To: T10 Technical Committee  
 From: Rob Elliott, HP (elliott@hp.com)  
 Date: 12 April 2007  
 Subject: 07-119r1 SAS-2 Far-end retimed loopback phy test function

## **Suggested changes to SAS-2**

**Figure 1 — Far-end retimed loopback phy test mode**

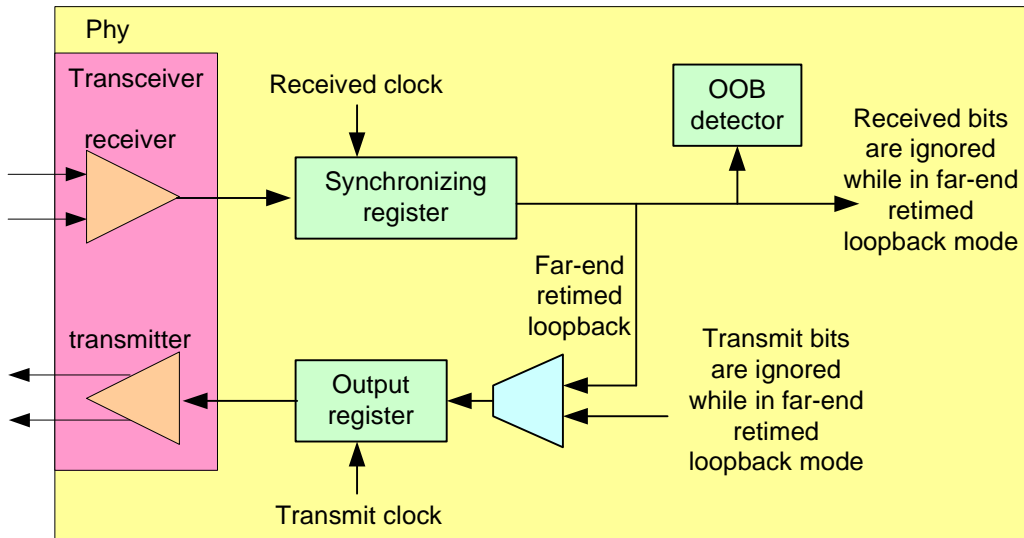
A phy performing the far-end retimed loopback phy test function is considered to be in the far-end retimed loopback phy test mode.

When transmitting to a phy in the far-end retimed loopback phy test mode, the test equipment:

- a) shall transmit valid 8b10b characters and D.C. idle;
- b) shall transmit deletable primitives according to 7.3;
- c) shall not transmit COMINIT pattern until it wants to exit the far-end retimed loopback phy test function.

Upon entry into the far-end retimed loopback phy test function, the phy shall transmit TRAIN\_DONE.

While performing the far-end retimed loopback phy test function, the phy:

- a) shall perform clock recovery, synchronizing the received signal to its transmit clock, and perform dword synchronization;
- b) should delete each deletable primitive that it receives;
- c) shall either delete invalid dwords or convert them into ERROR primitives;
- d) shall retransmit each dword that is not a deletable primitive;
- e) shall transmit a deletable primitive whenever it underflows (i.e., whenever the transmitter is ready to transmit a dword but the receiver has not provided another dword to transmit); and
- f) shall transmit dwords using valid disparity based on the transmitted dword stream.

While in the far-end retimed loopback phy test mode, the phy shall operate its OOB signal detector to detect COMINIT.

The phy shall remain in the far-end retimed loopback phy test mode until:

- a) the phy test function is stopped via another phy with the SEND DIAGNOSTIC command Protocol-Specific diagnostic page for SAS (see 10.2.9.1) or the SMP PHY TEST FUNCTION function with the PHY TEST FUNCTION field set to 00h (i.e., STOP);
- b) the phy receives a COMINIT; or
- c) power off.

**Figure 2 — Far-end retimed loopback phy test mode usage**

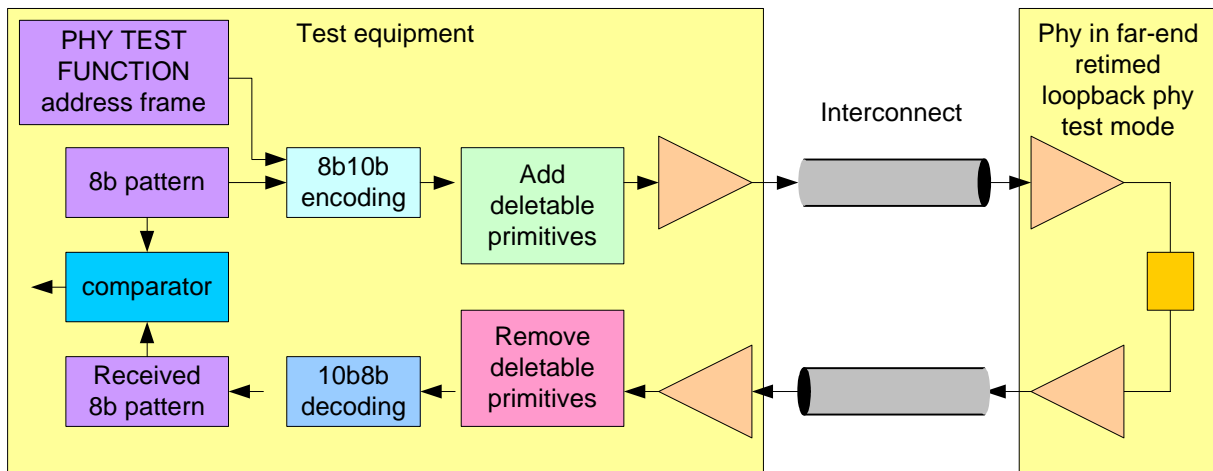
[Figure 1 shows usage of the far-end retimed loopback test mode.](#)
